Authors' Response to Reviews of

Hydrological regime of Sahelian small water bodies from combined Sentinel-2 MSI and Sentinel-3 SRAL data

Mathilde de Fleury, Laurent Kergoat, and Manuela Grippa

Hydrol. Earth Syst. Sci. Discuss., <https://doi.org/10.5194/hess-2022-367>, 2022,

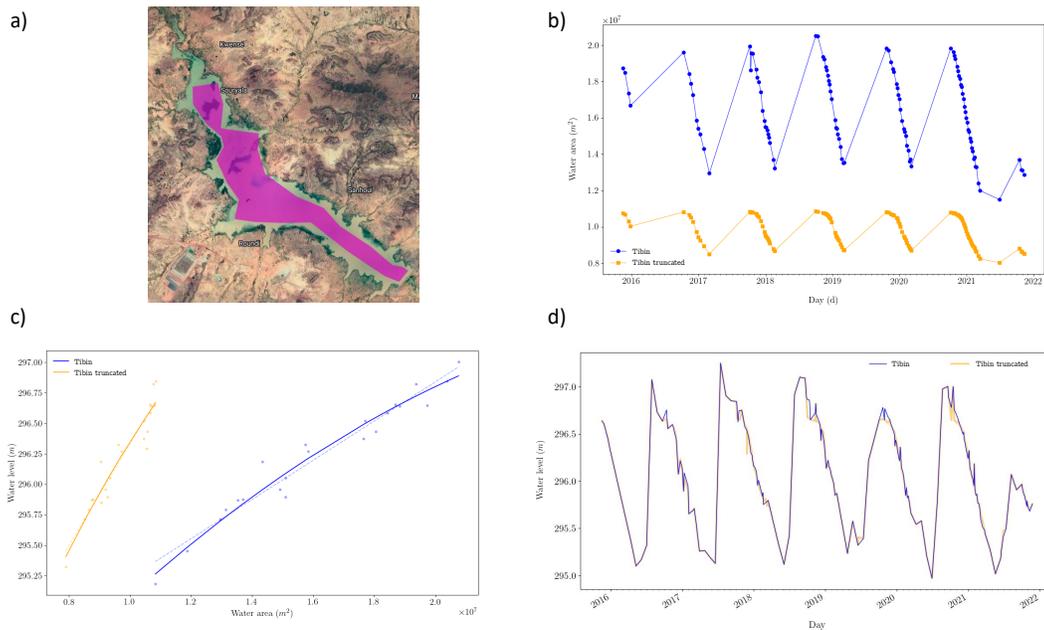
RC: Page 16, lines 240-241

The authors mentioned that "There is no need to derive an estimation of water area of the whole lake". What would be the impact of underestimating the surface areas of water bodies on water heights? Could it be significant or not?

AR: We agree that this point needs clarification, since it is not straightforward. We therefore modified the text as follows (modifications in red): "However, the method developed here is not very sensitive to systematic errors in water body surface area detection. ~~Since areas are used to interpolate water heights, via the A-H curve, there is no need to derive an estimation of water area for the whole lake and part of lake can be discarded, provided this is systematic.~~ **Given that water areas are only used to estimate water heights via the A-H curve, systematic errors in water area detection will not affect the final height estimation. For example, systematically missing a part of the lake in the water area detection (truncation) will modify the absolute water area values in the A-H curve but will not change the water height values.** This situation is encountered for some lakes without a well identified connection to a river or with another lake or lakes that overflow, for example downstream of a dam. ~~, which is truncated to avoid misclassifications.~~ Similarly, ~~as long as the threshold applied to the MNDWI consistently detects water pixels even in the presence of vegetation, the time series of water areas has consistent variations even if the absolute value of the water area may not be correct.~~"

Figure AR1, below, shows a case study that illustrates our point.

Figure AR2: Five-year average residual water balance compared to MNDWI threshold for each lake

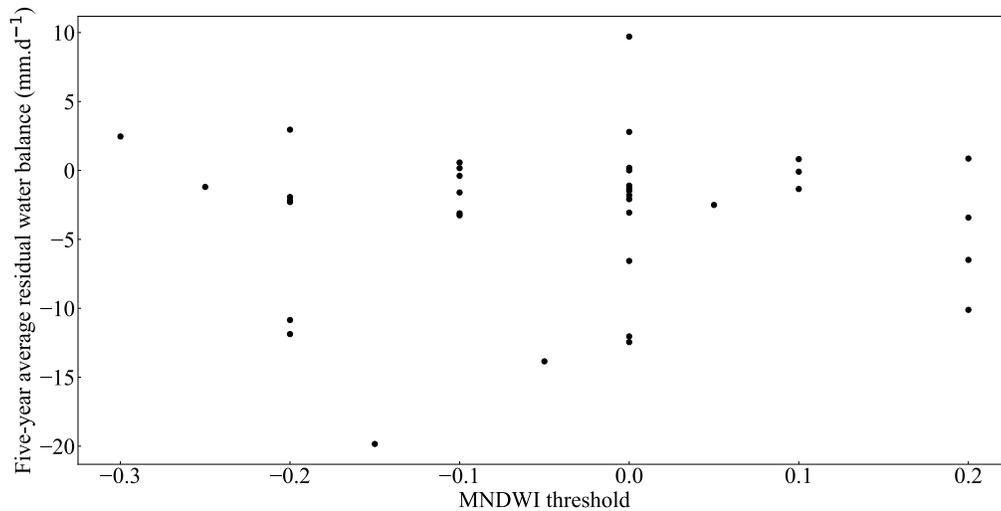
RC: *It makes sense that the water index thresholds might vary by water body. Additionally, it would be a useful contribution to understanding the hydrological regimes if the mNDWI thresholds could be used to explain the variability between groupings of similarly reflecting lakes. (For example, grouping lakes where $mNDWI=0$, $mNDWI>0.1$, $mNDWI<-0.1$)*

AR: This is an interesting idea. We have tested it but we did not find any correlation between the MNDWI threshold and the value of the five-year average residual water balance (Fig. AR2 below). Moreover, looking at the spatial distribution of the MNDWI threshold (Fig. AR3 below), we also cannot conclude about patterns reflecting the hydrological regime or the typology of water bodies (e.g. connection to rivers, large lakes, small lake, turbid, clear, ect) and the threshold retained. It should be noted that for a given lake, there is usually a range of MNDWI thresholds that work equally well. This may explain why we do not find evident relationship between MNDWI threshold and water bodies characteristics.
